November 03, 2023

RE: Responses to Comments
Dutch Bros Coffee
1125 Snow Vista Boulevard Southwest, Albuquerque, New Mexico 87121
Our Job No. 23007

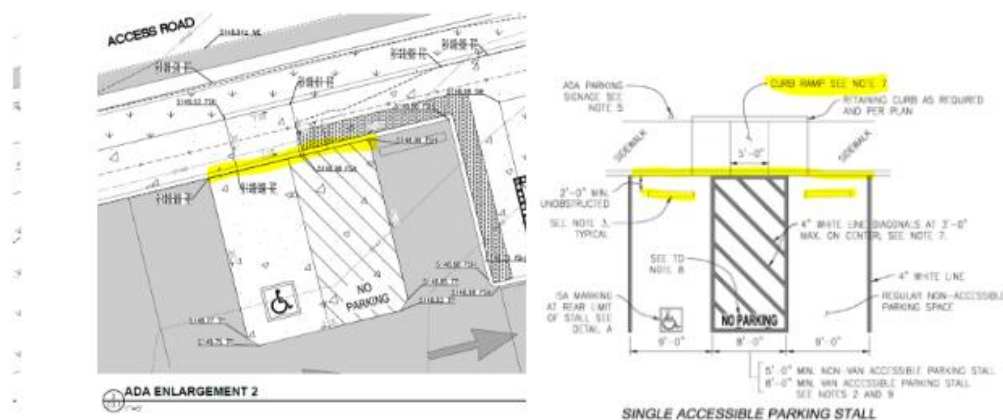
5. *Show all drive aisle widths and radii. Some dimensions are not shown.*

Response: the drive aisle widths and radii have been added.
